**REGULAR MEETING OF THE THIRD LAGUNA HILLS MUTUAL  
ARCHITECTURAL CONTROL AND STANDARDS COMMITTEE**

**Thursday, January 18, 2018 – 9:30 a.m.  
Laguna Woods Village Community Center Sycamore Room  
24351 El Toro Road**

**DATE:** January 18, 2018  
**FOR:** Architectural Control and Standards Committee  
**SUBJECT:** Variance Request  
Mr. Rodolfo Alvarez of 3064-A (San Clemente, OO03\_2)  
Window Modifications to Kitchen and Bedroom

**DATE:** January 17, 2018  
**FOR:** Architectural Control and Standards Committee  
**SUBJECT:** Variance Request  
Ms. Sondra Baren of 3386-C (Andaluz, P203RA)  
Retain Non-Standard Front Entry Door Color

PROPOSED WINDOW  
ELEVATION # 2  
MASTER BEDROOM  
WINDOW

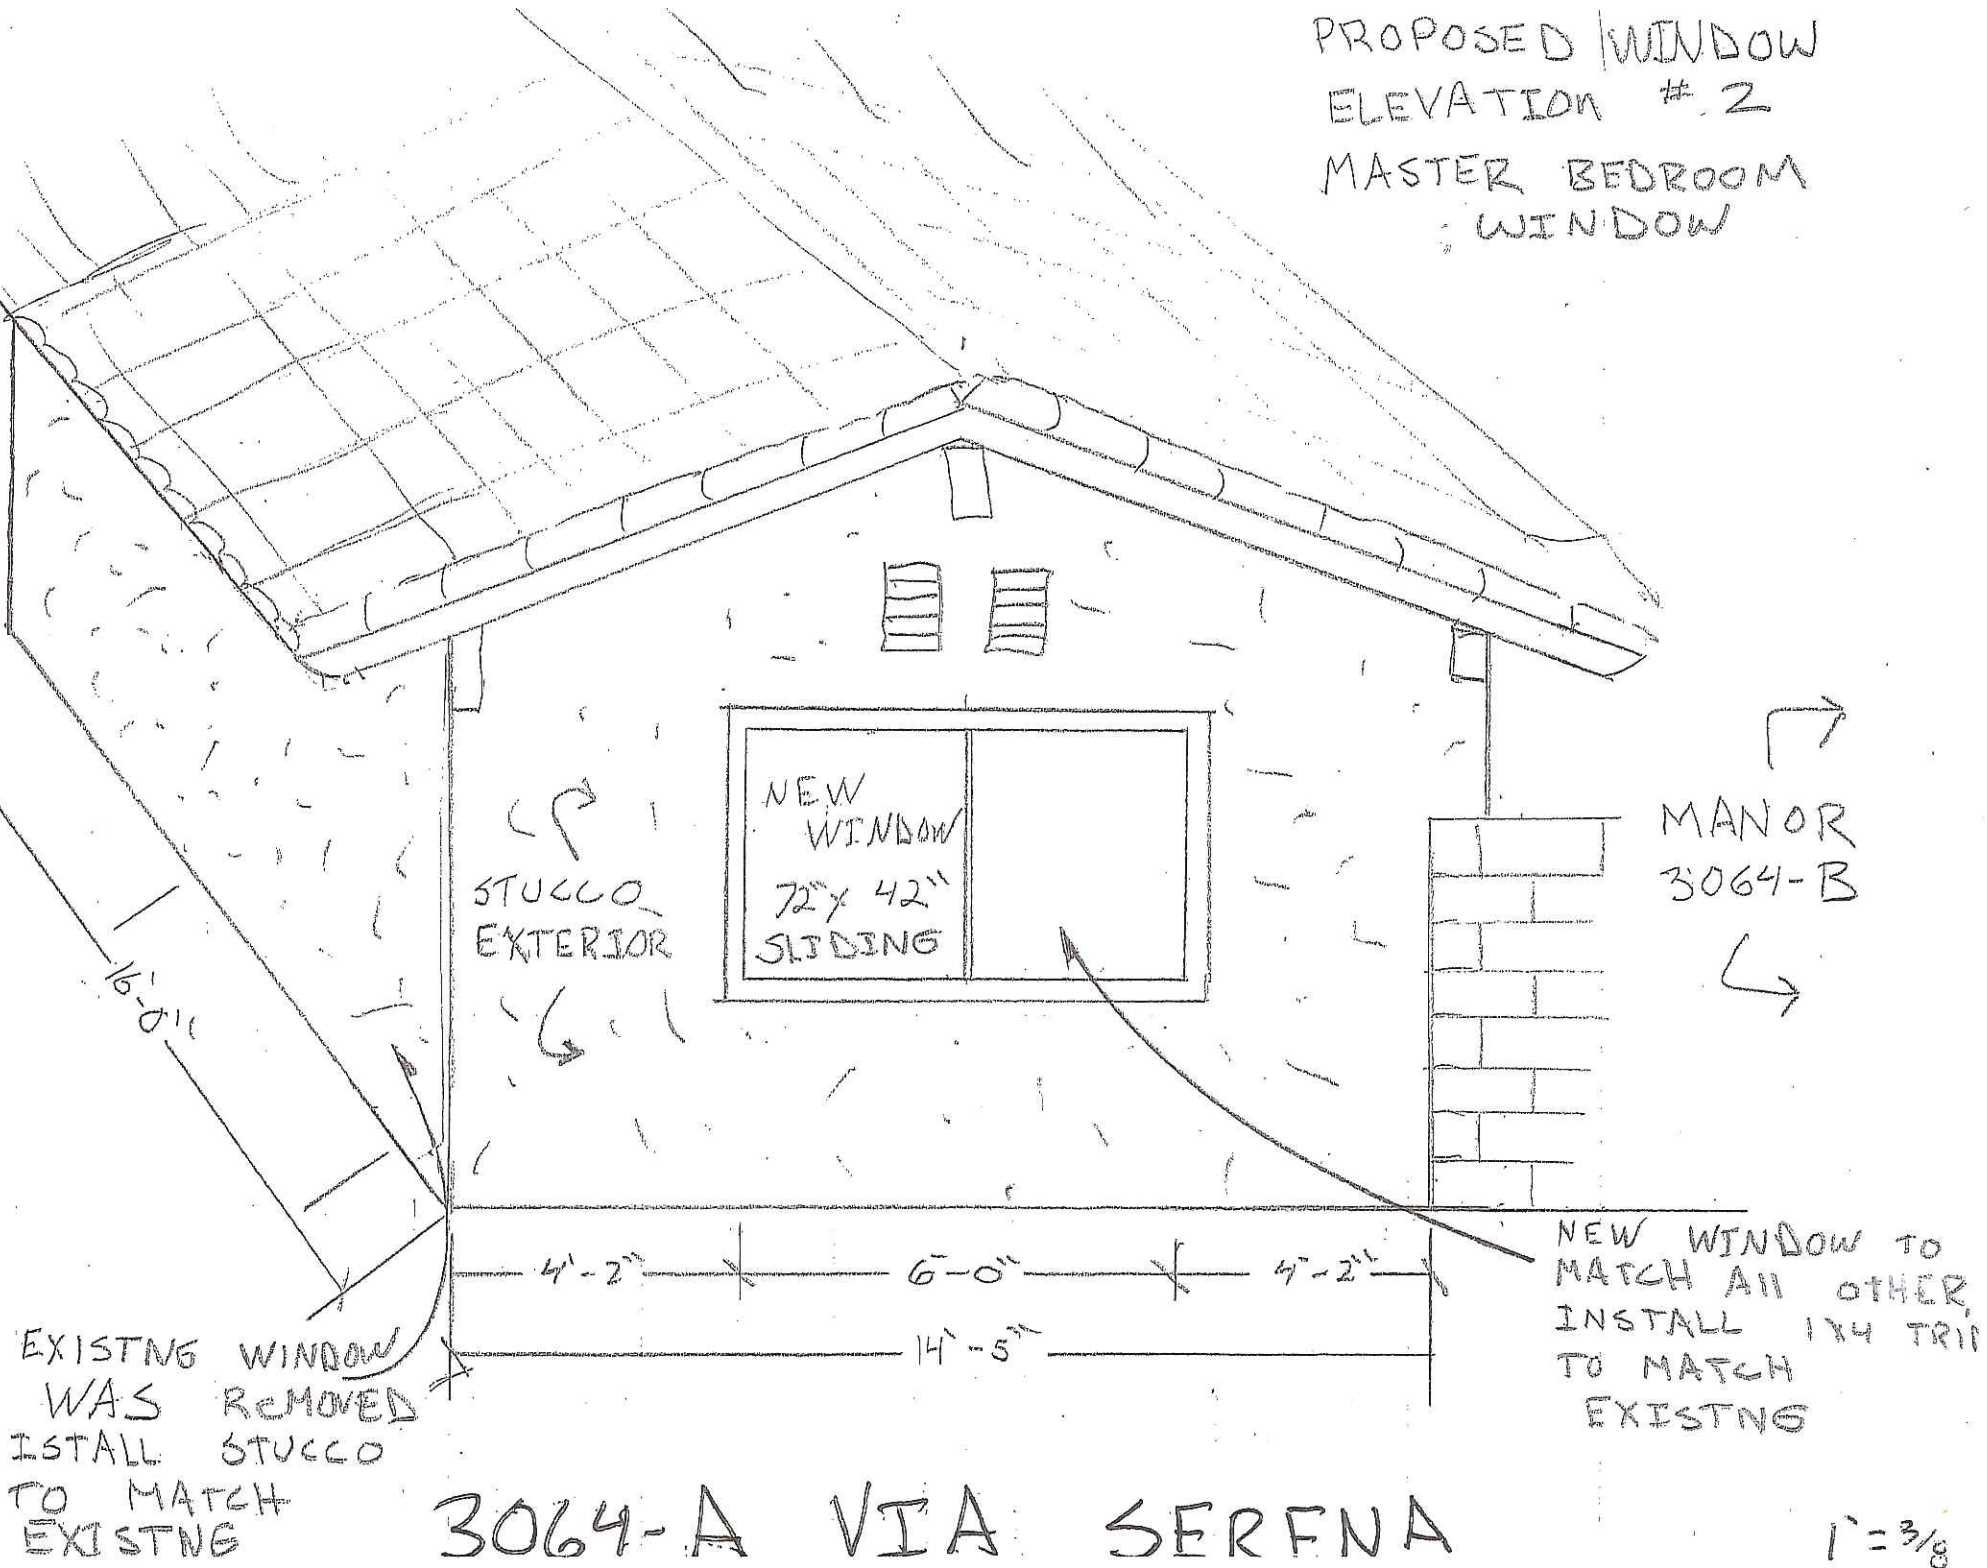
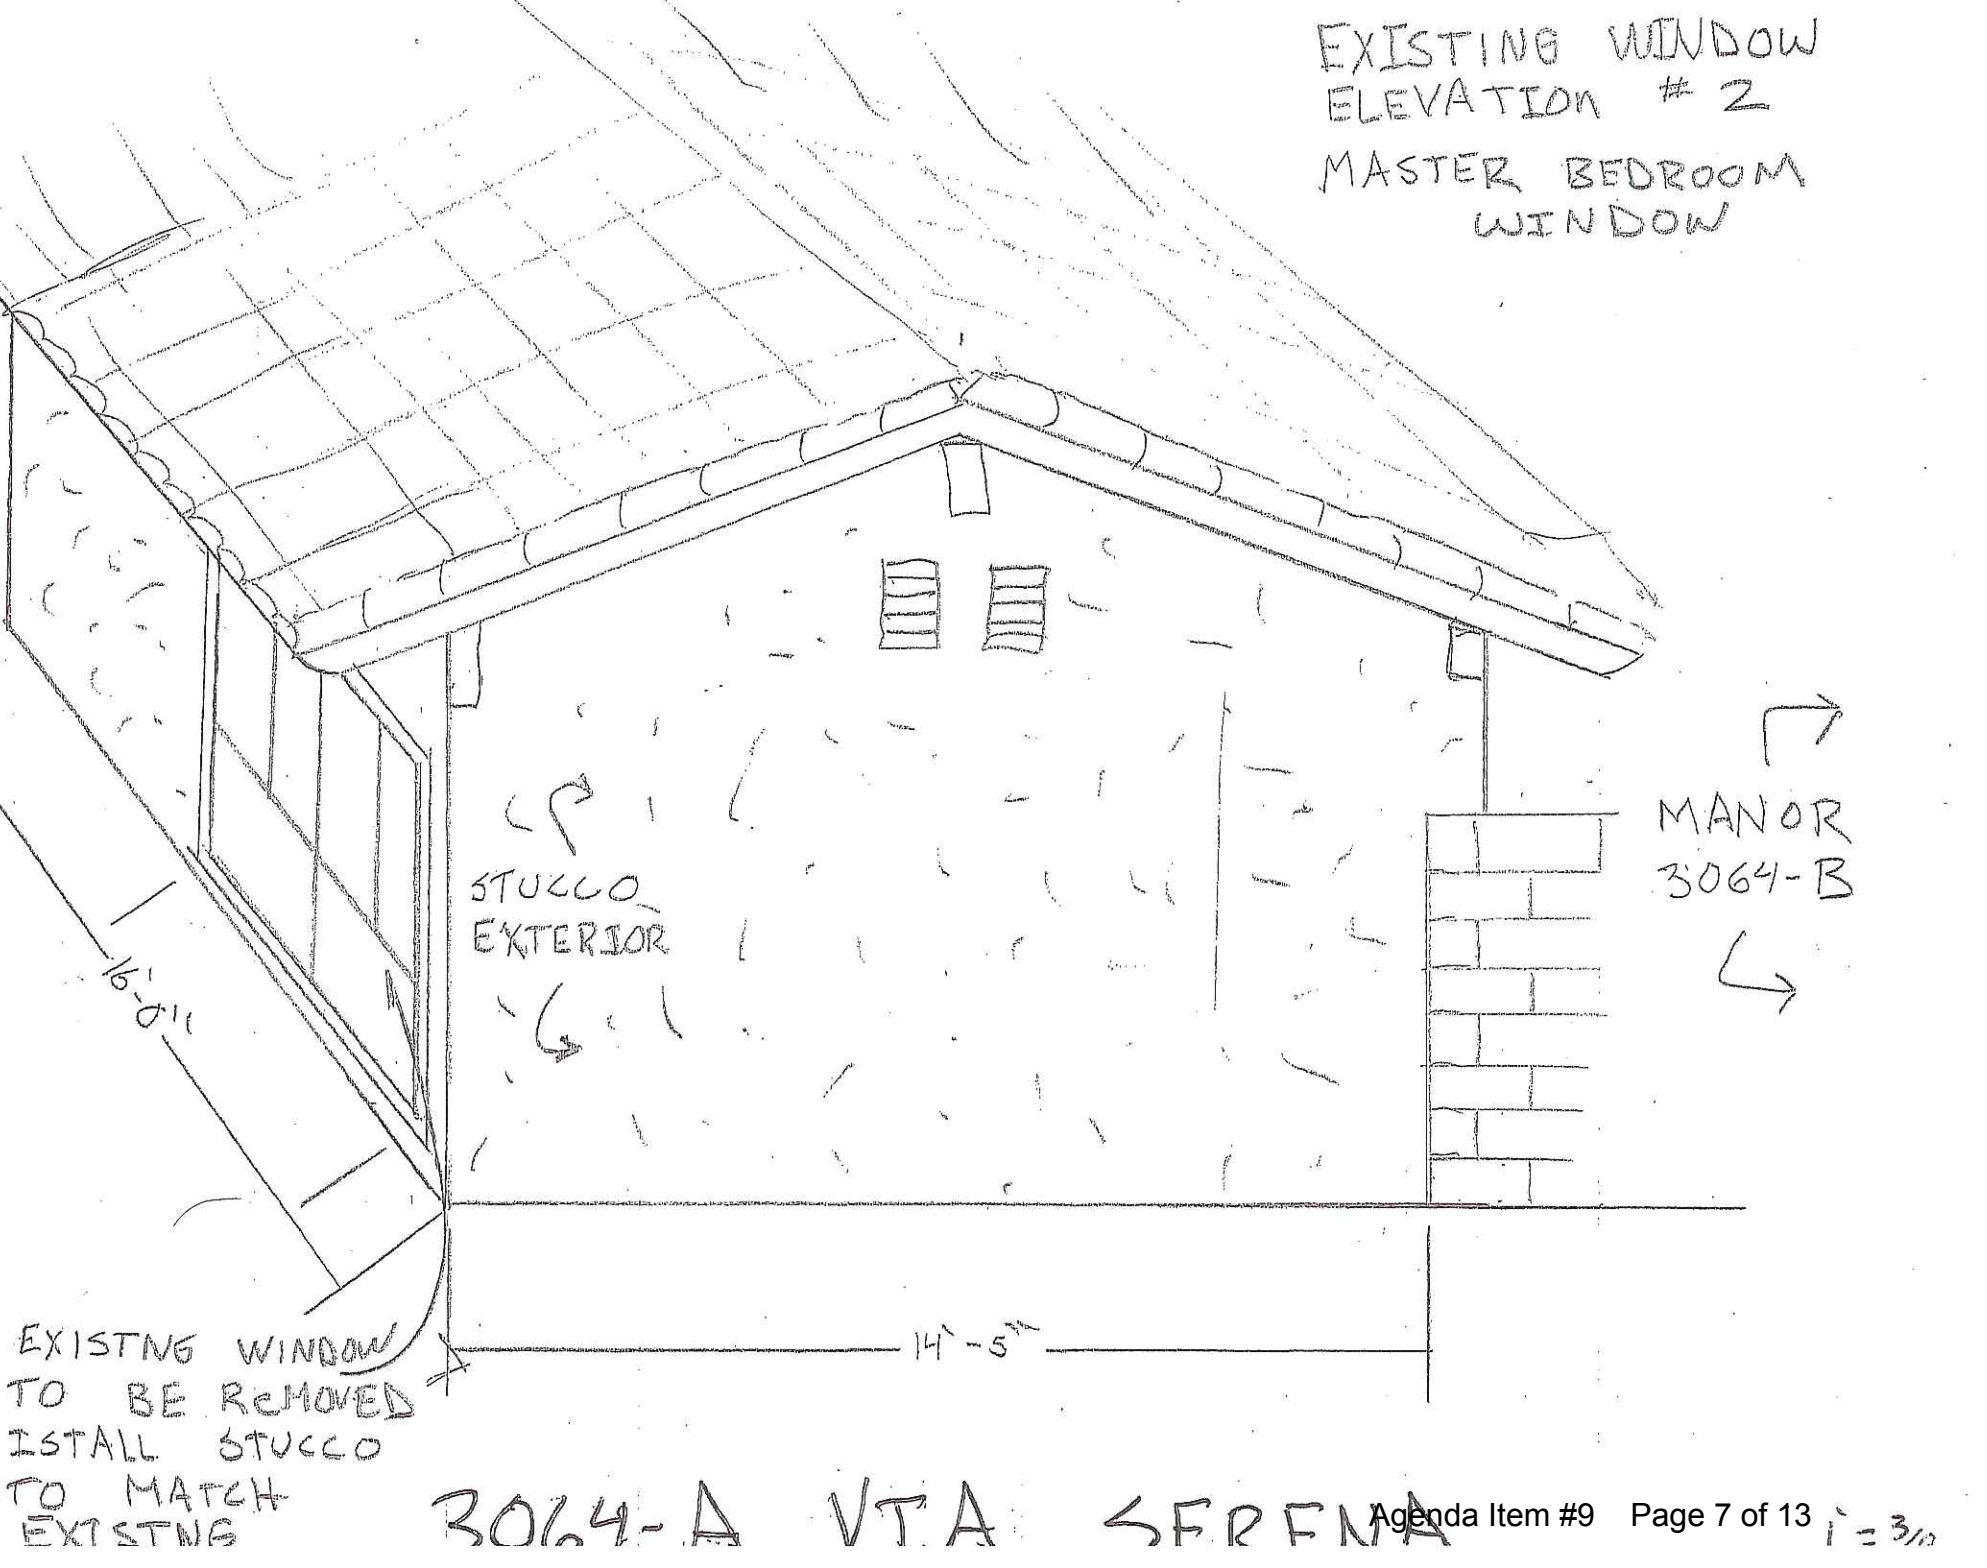
Mr. Alvarez is also proposing to remove the southeast master bedroom window (see Attachment 4) that measures seven feet, eleven inches wide by six feet, four inches tall, fill the area with wood frame with stucco finish to match the rest of the building and install a new sliding window on the northeast facing wall measuring six-feet wide by three-foot, six-inch tall.

The architectural drawings for a typical San Clemente model unit showing let-in (diagonal) bracing on the same wall as the proposed new bedroom window, Staff had included a condition to provide structural drawings signed and wet stamped by a licensed architect or structural engineer prior to a Mutual Consent being issued. Additionally, Staff will add a condition that the entire wall receives new stucco to ensure consistent appearance.

12. Any stucco patch shall match existing adjacent stucco walls in color and texture. If any stucco is removed to accomplish the alteration, the entire wall shall receive new stucco finish to ensure consistent appearance.

Front door  
3386 C Punta Alta

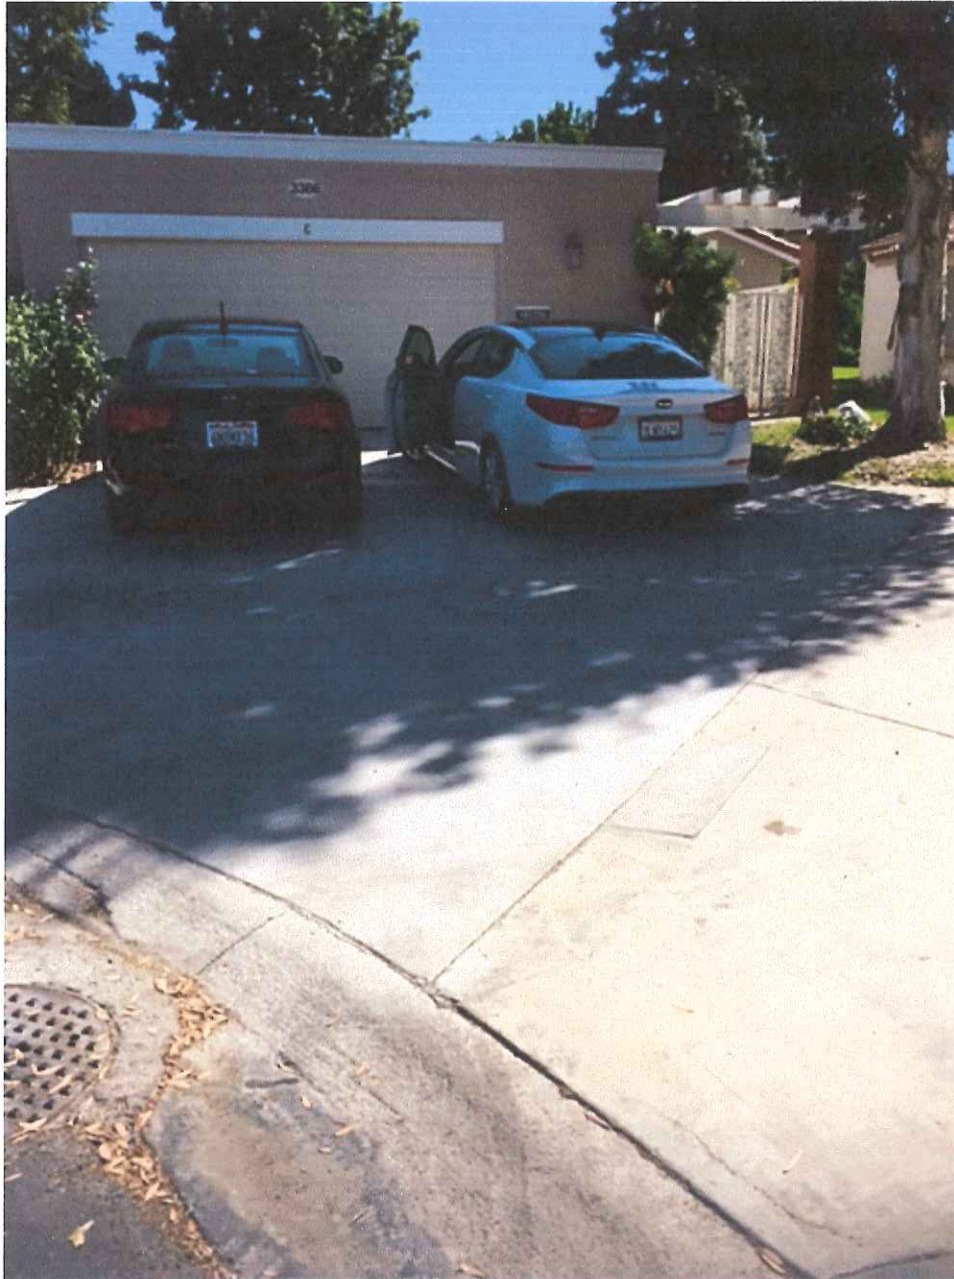
Ms. Baren is requesting to retain the green color used on his entry door. The door is not directly visible from the street.

Third Mutual Alteration Standards Section 10 - Doors, Exterior (Revised March 2003), paragraph 3.1 states, "All doors shall be painted or stained to maintain an appearance that conforms to the approved paint color criteria as dictated by the Mutual's Policy on Exterior Paint Colors and Procedures." The current color scheme for Building 3386 during the last paint program visit in 2013 used Basic Khaki, Woodruff and White High Hiding. Green was not an option for that building's scheme.

Staff seeks recommendation for the Board to retain a non-standard color (green) for the front entry door per the Conditions of Approval shown in Appendix A.
